**CHARTER TOWNSHIP OF GARFIELD  
PLANNING COMMISSION MEETING**

**CHARTER TOWNSHIP OF GARFIELD  
PLANNING COMMISSION MEETING  
November 6, 2024**

<b>Charter Township of Garfield</b> <b>Planning Department Report No. 2024-108</b>			
Prepared:	December 4, 2024	Pages:	3
Meeting:	December 11, 2024 Planning Commission	Attachments:	<input checked="" type="checkbox"/>
Subject:	Copper Ridge PUD Major Amendment – Public Hearing		
Applicant:	Copper Ridge LLC / Constance Deneweth		
Agent:	Northview 22 LLC / Sarah Kever		
Owner:	Copper Ridge LLC / Constance Deneweth		
File No.	SUP-2000-08-O		
Parcel No.	05-096-900-00 and associated Copper Ridge parcels

JOB NUMBER:  
202723  
SHEET C-1

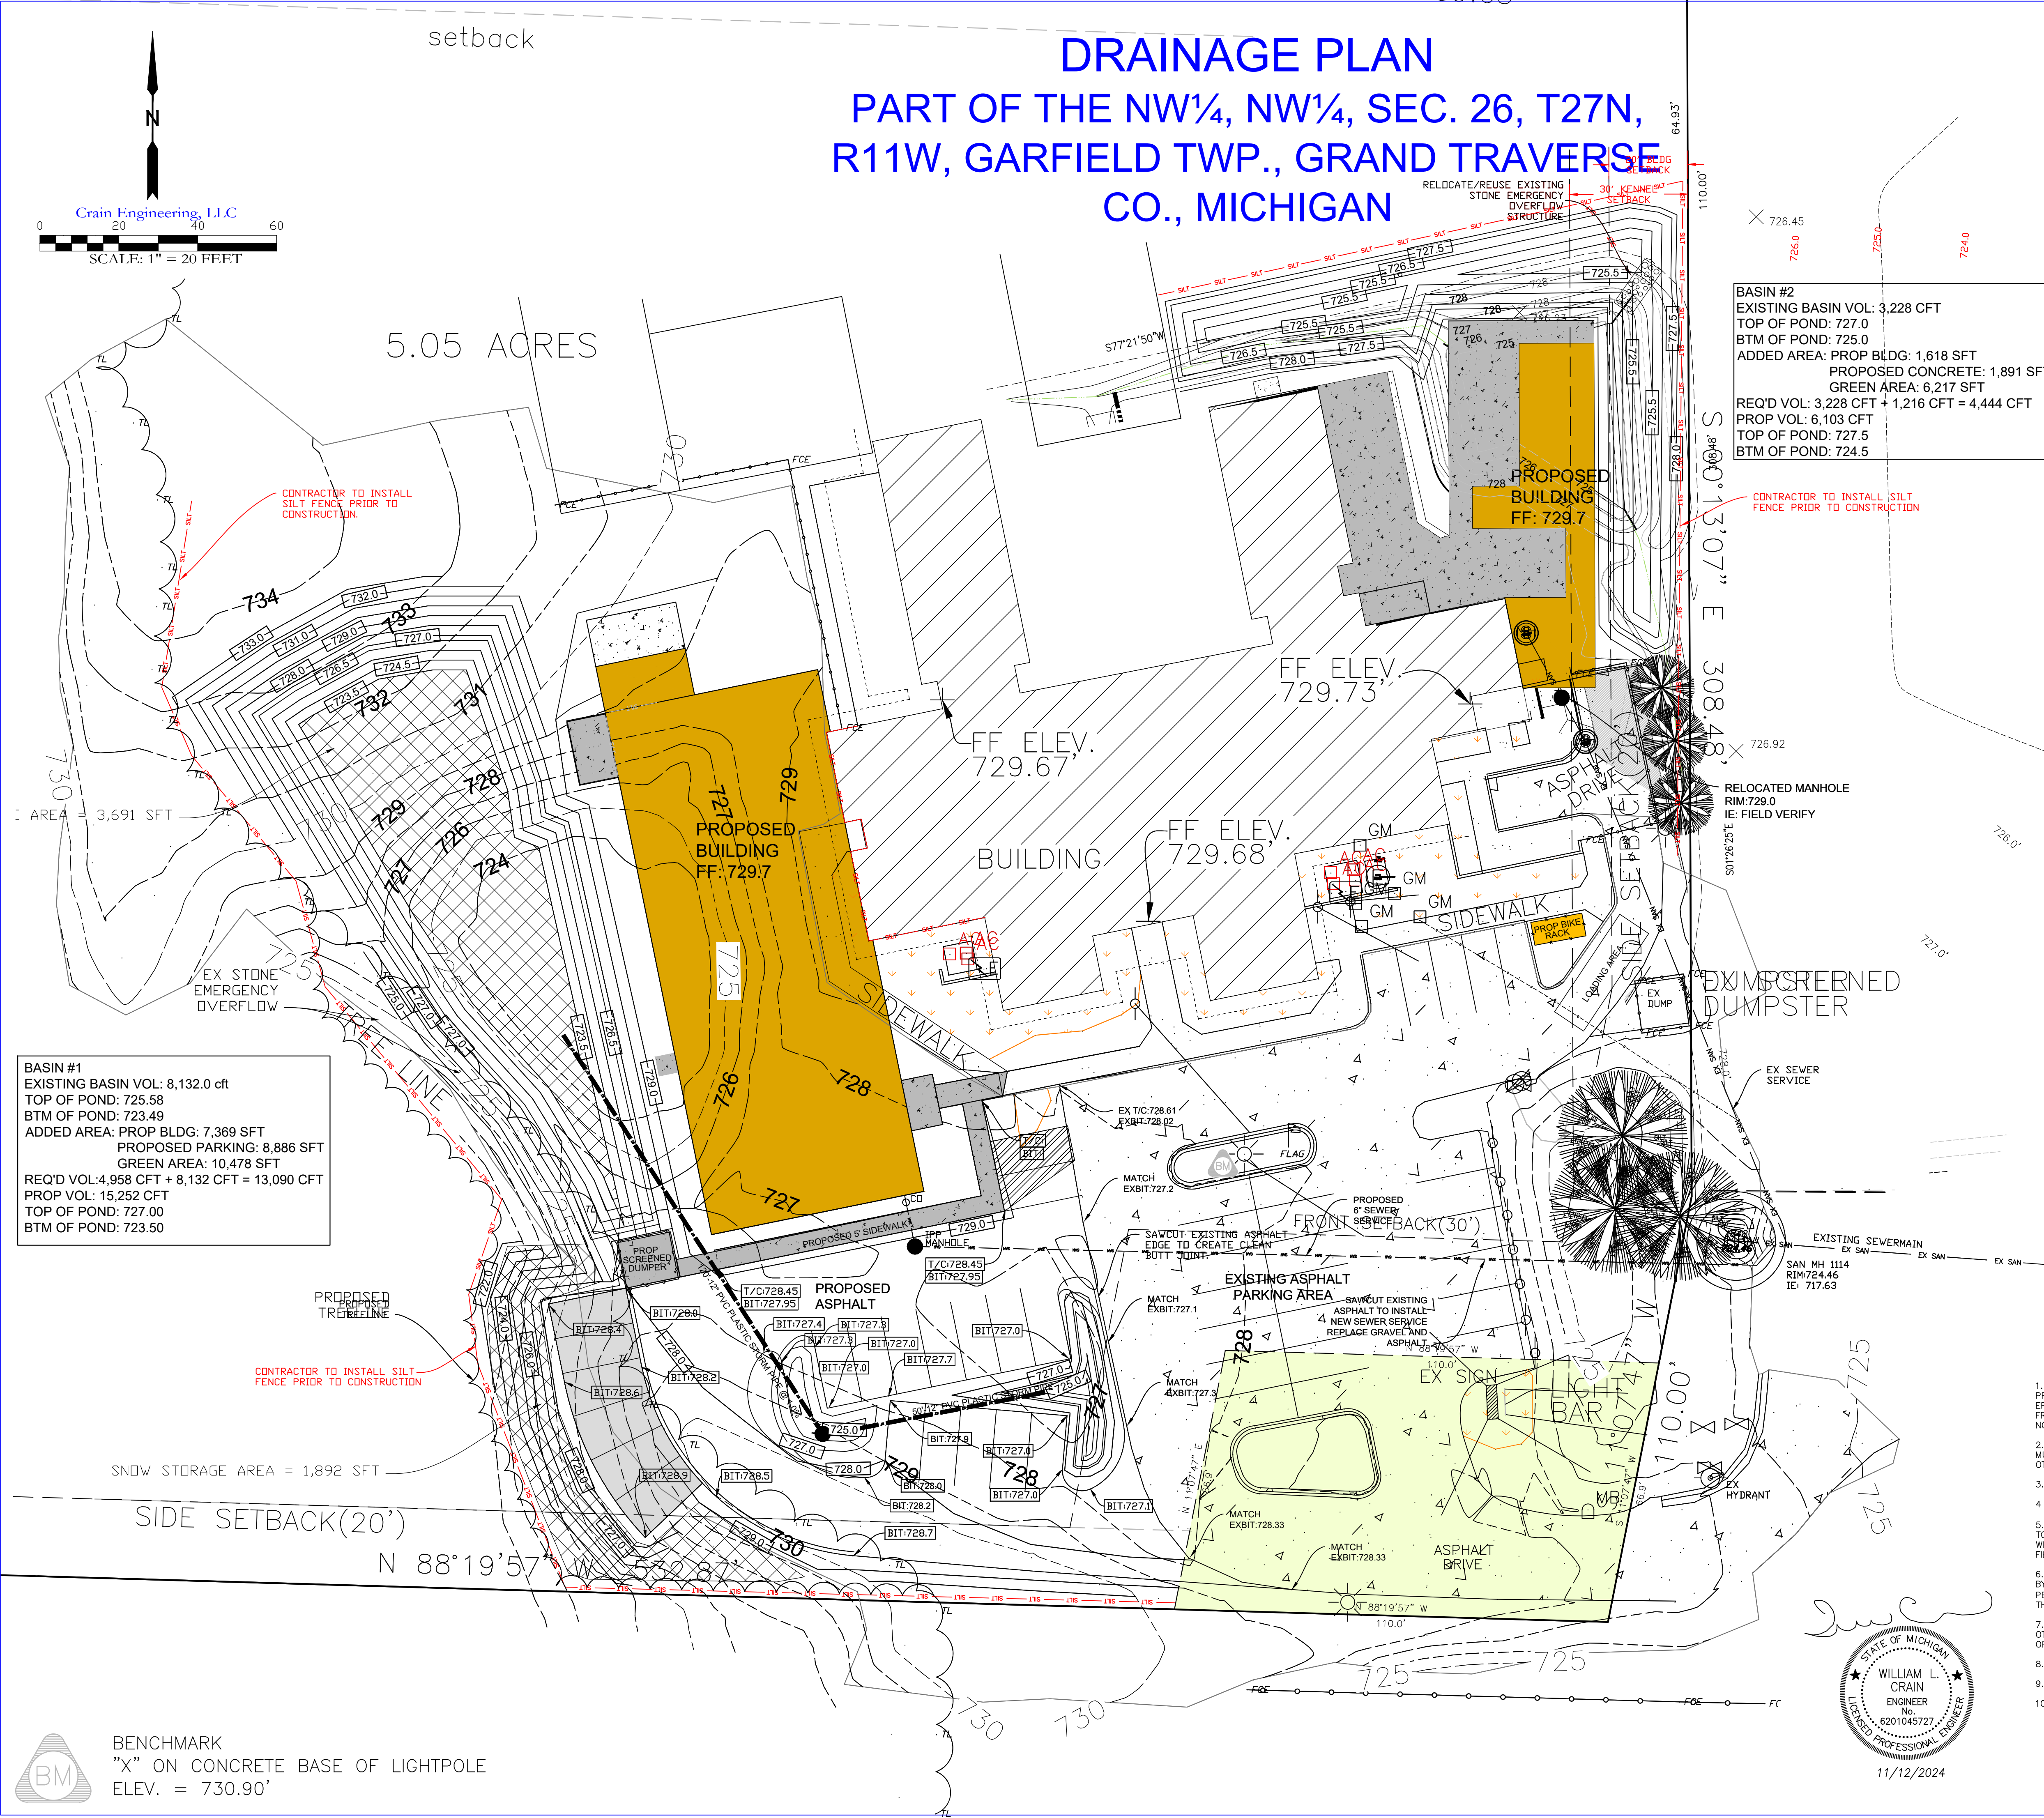
Snow storage is required at a ratio of ten (10) square feet per one hundred (100) square feet of parking area. Sheet C-1 includes snow storage calculations indicating a required snow storage area of 2,739 ft<sup>2</sup> and total snow storage area of 5,583 ft<sup>2</sup> provided.

Bicycle parking shall be provided at the rate of 2 bicycle spaces per 25 motor vehicle spaces. Based on this standard, 4 bicycle parking spaces are required. A proposed bike rack is shown at the southeast corner of the existing building. Details of the proposed bike rack are shown on Sheet C-1.

SHEET NO:  
SE2.1

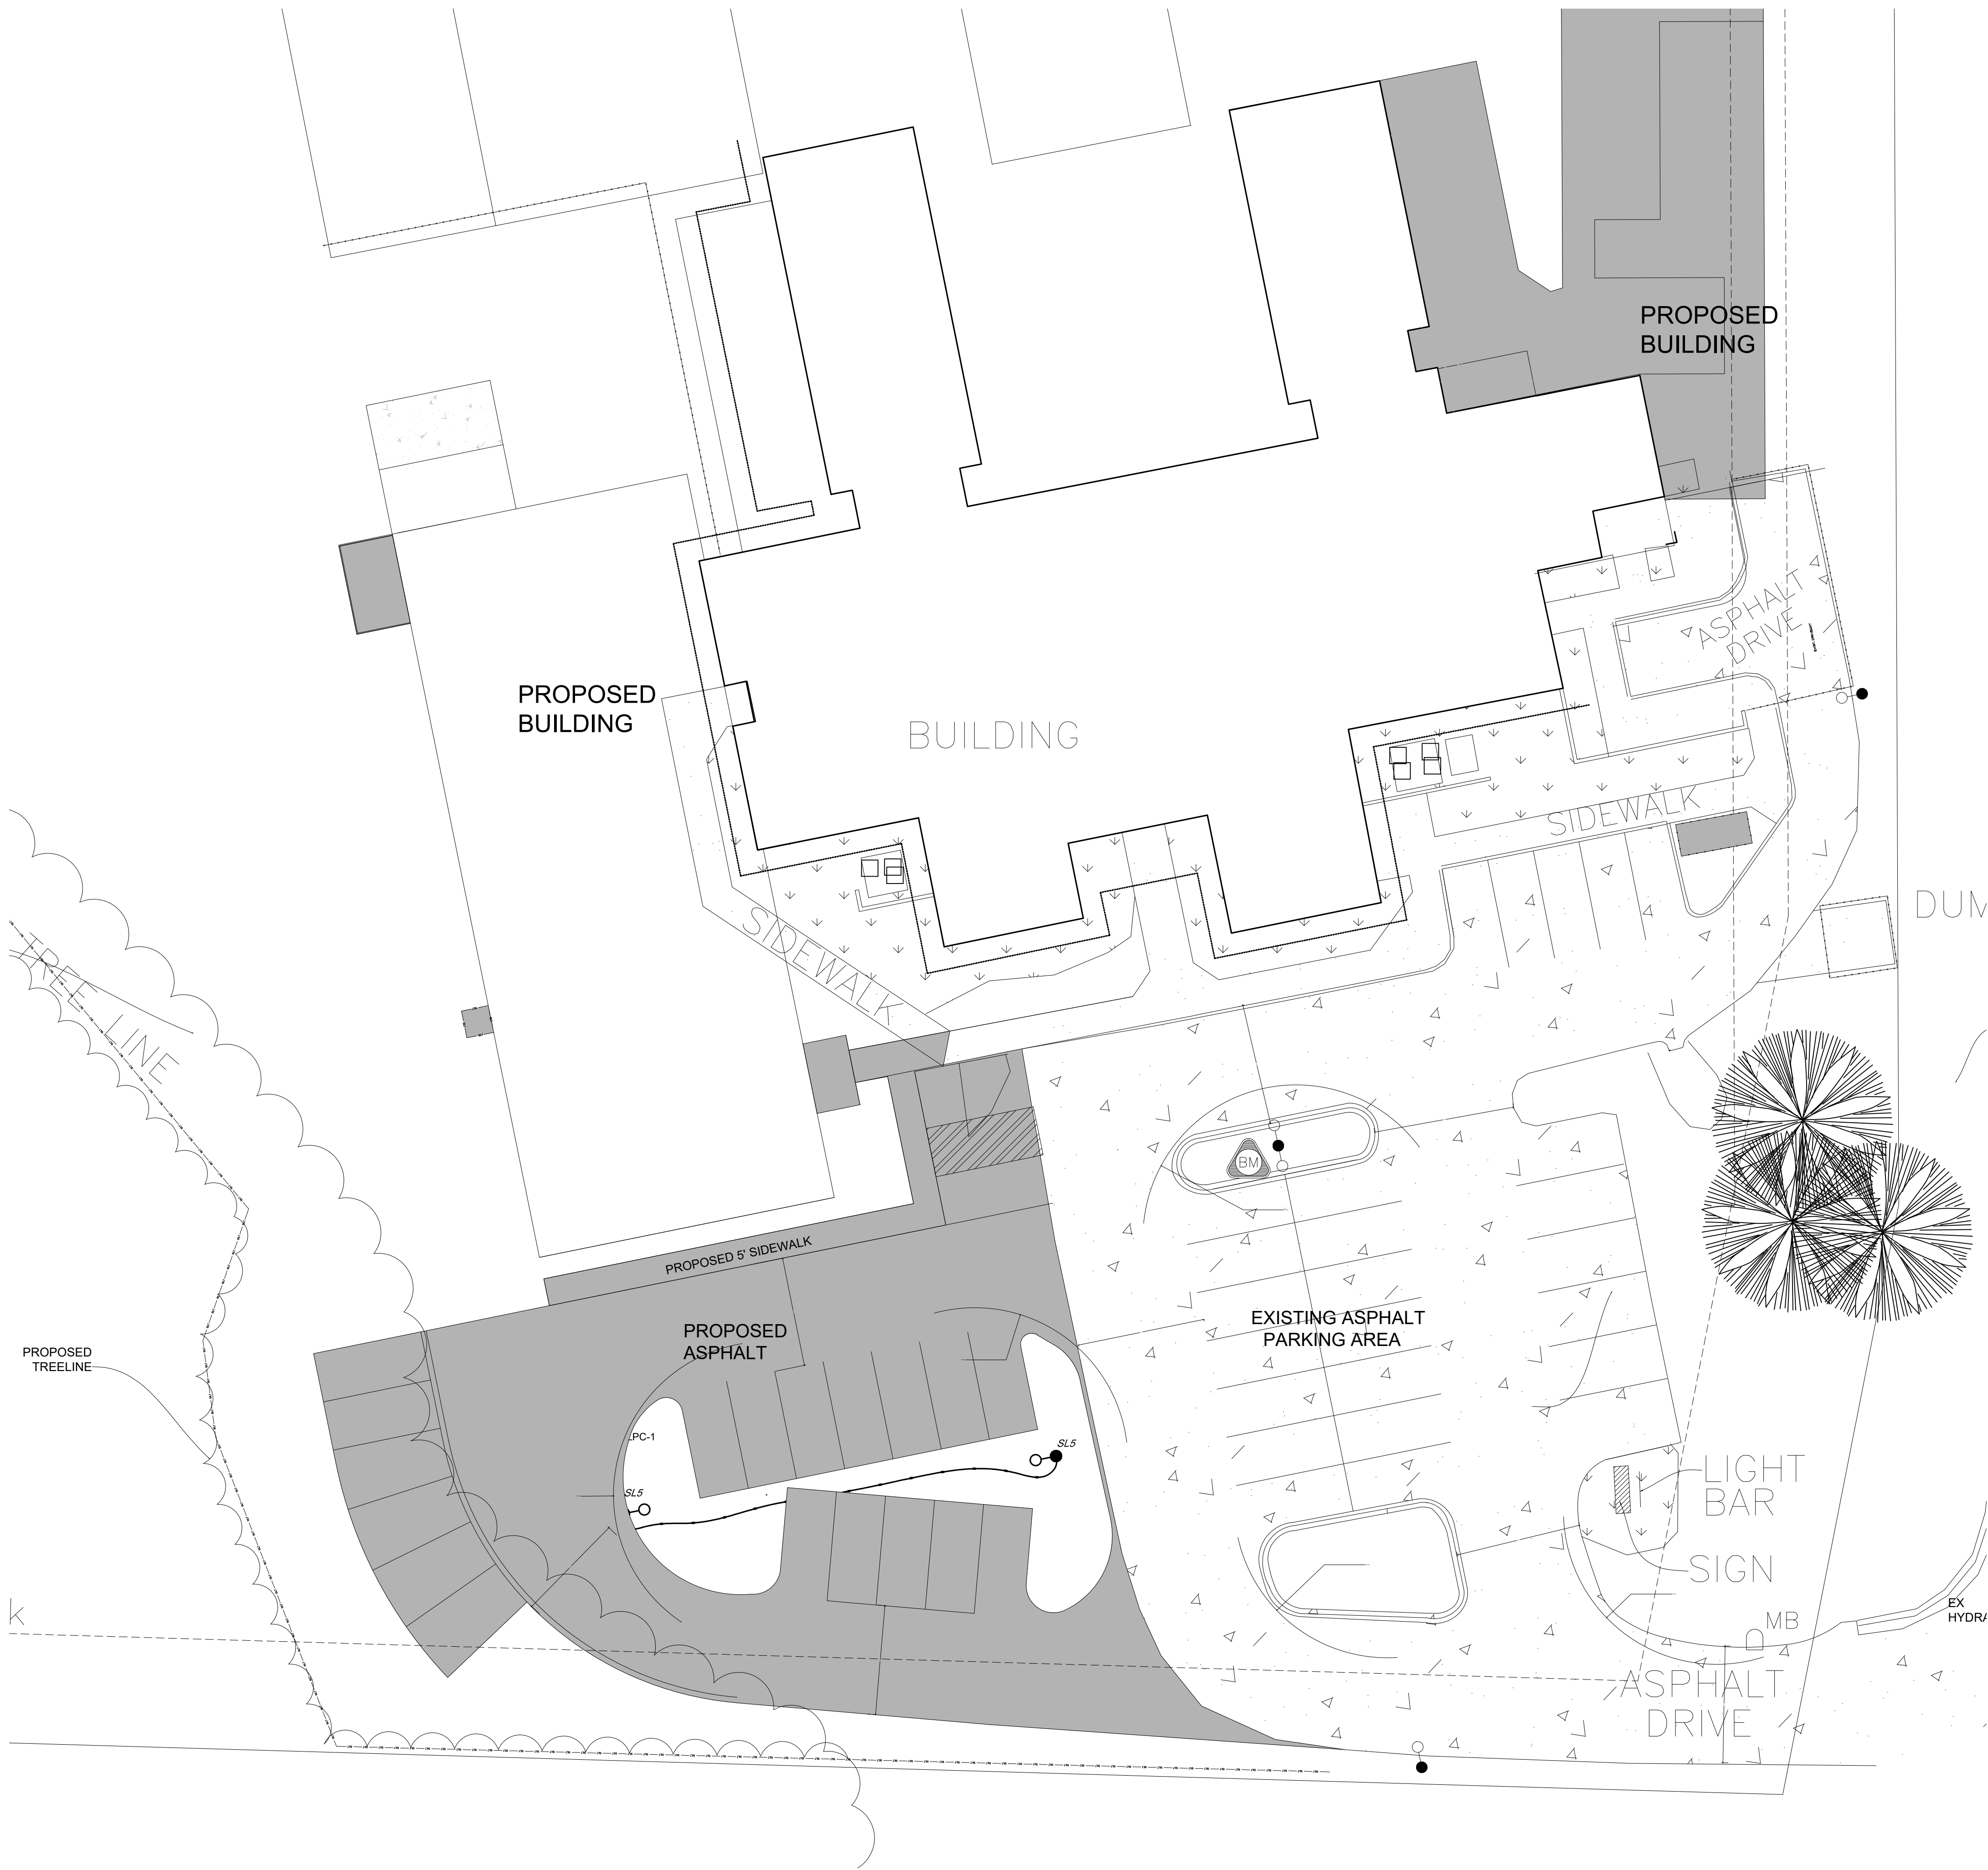
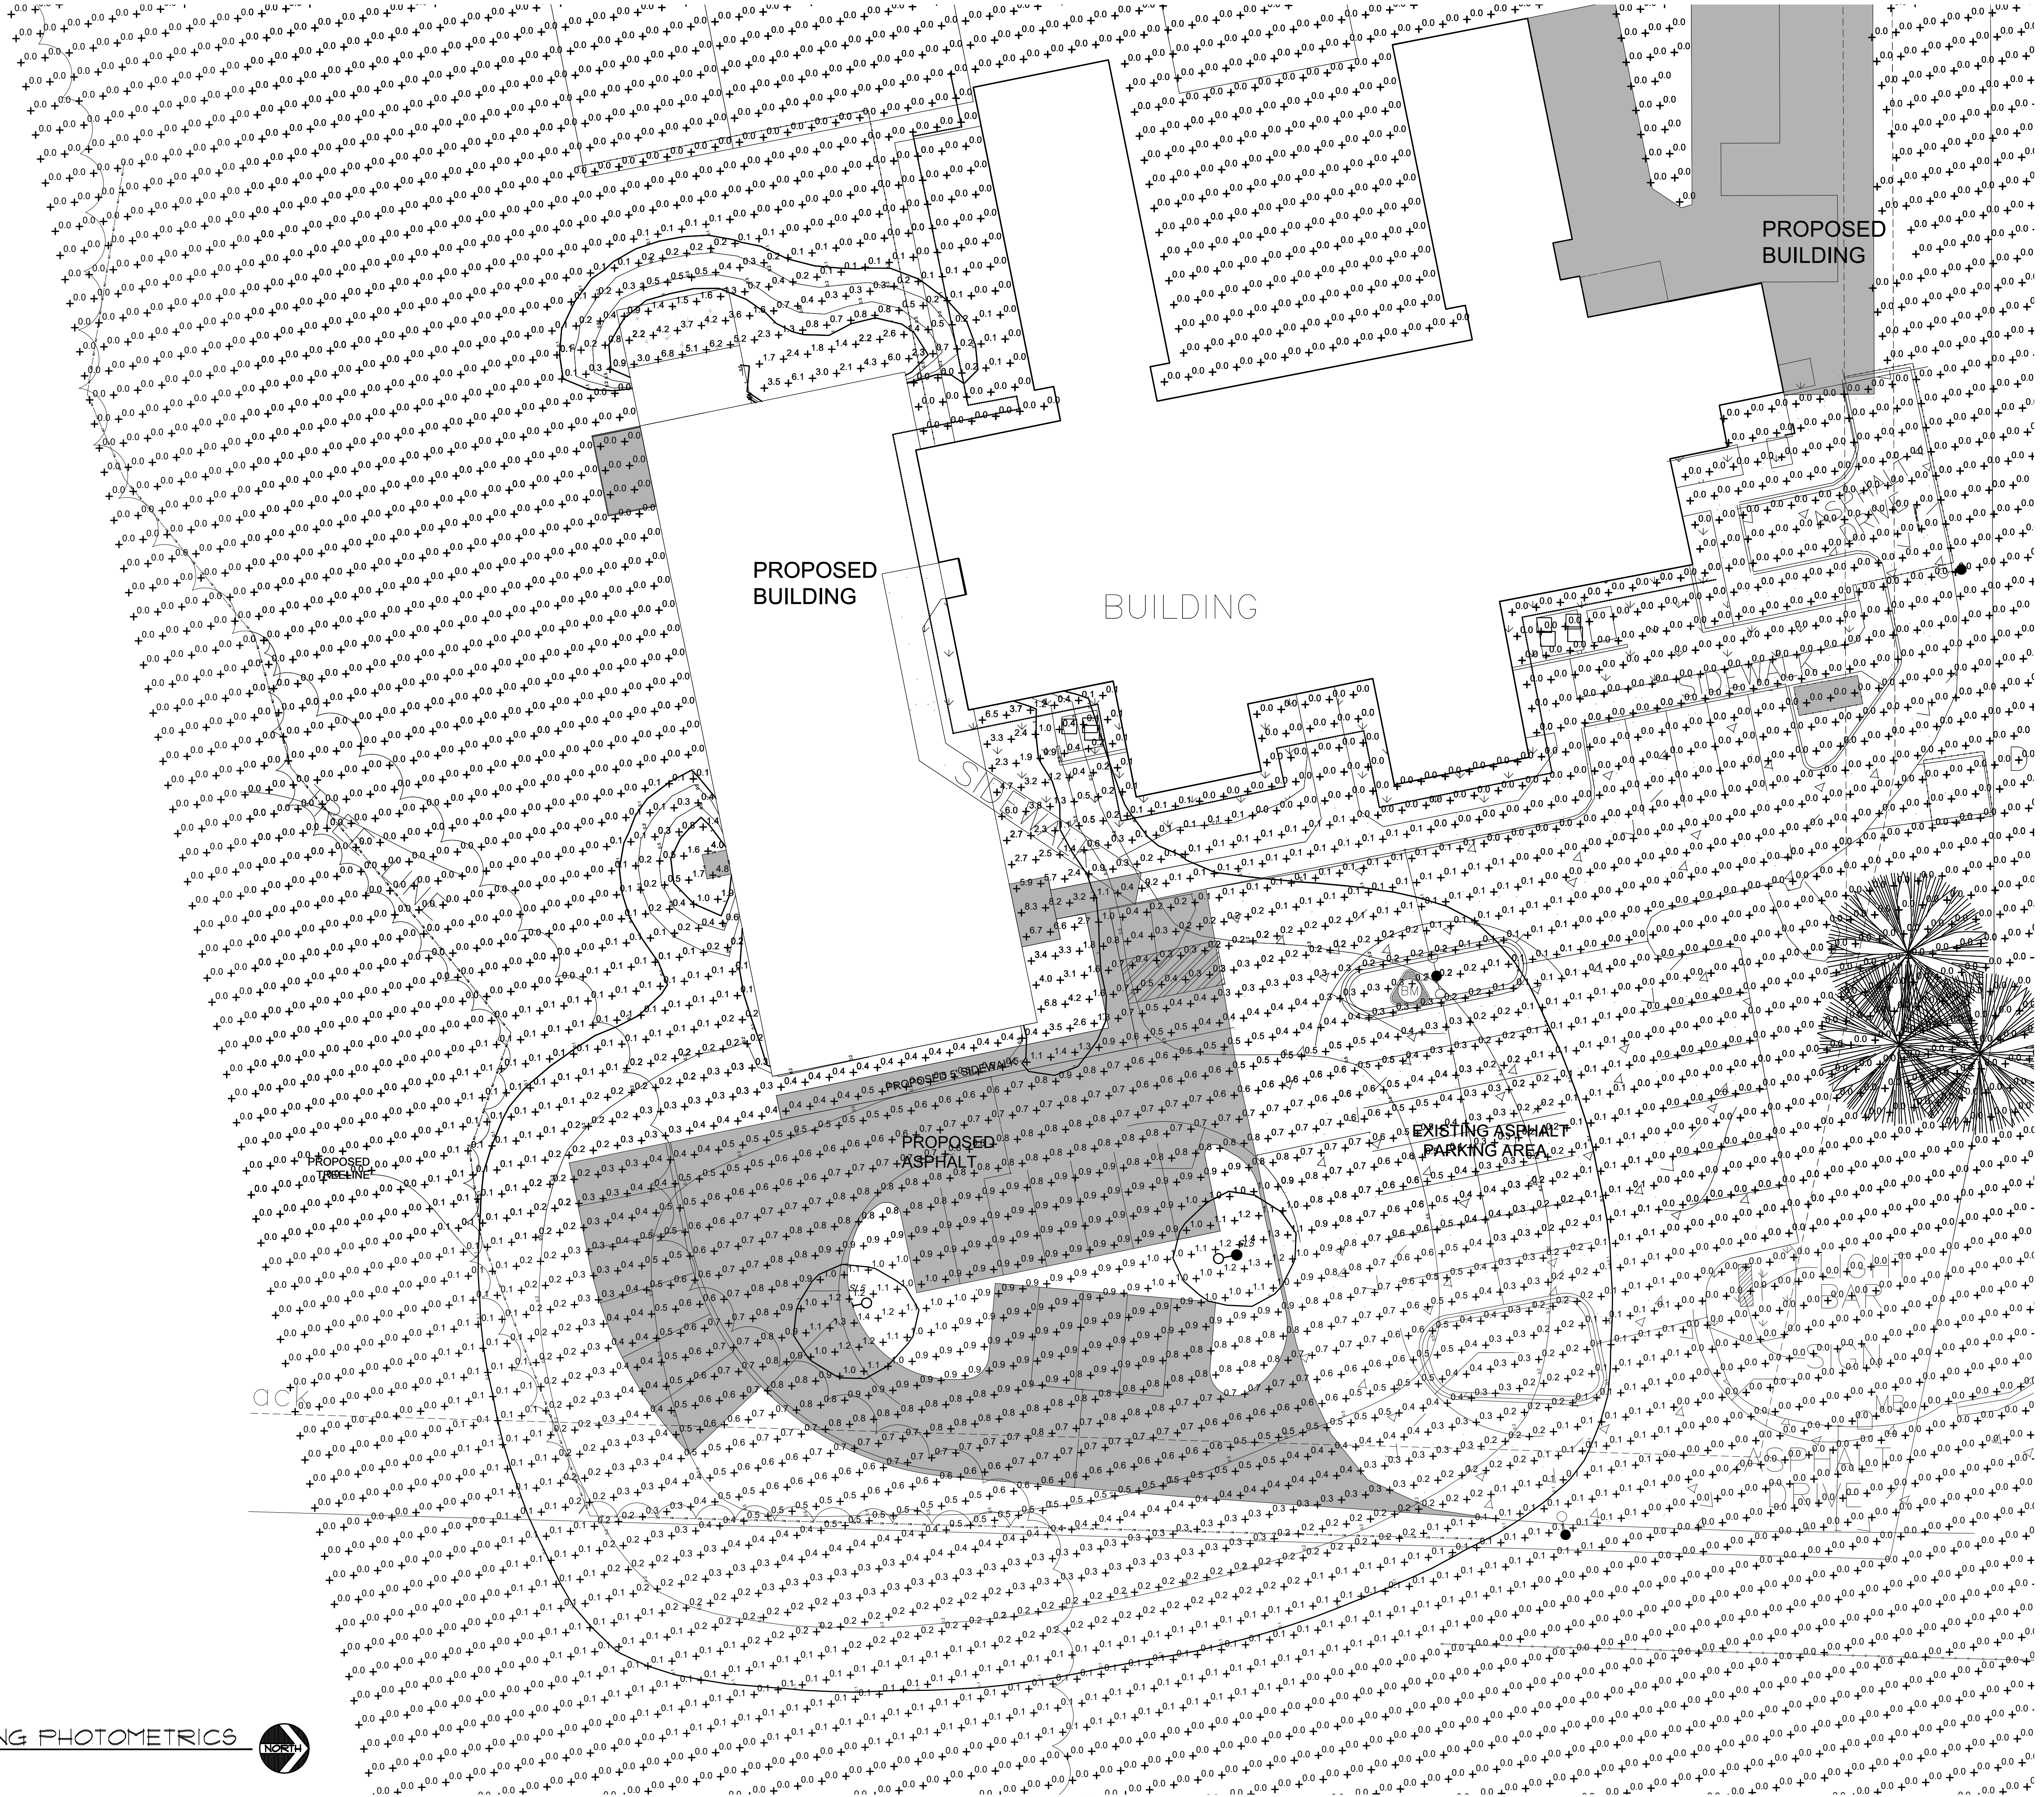
The site plan set includes an Electrical Site Plan (Sheet SE2.1) and Site Lighting Photometrics (Sheet SLC) to demonstrate site lighting. The applicant has also submitted a cut sheet of the proposed lighting fixtures. The lighting standards of Section 517 of the Zoning Ordinance are described by the following:
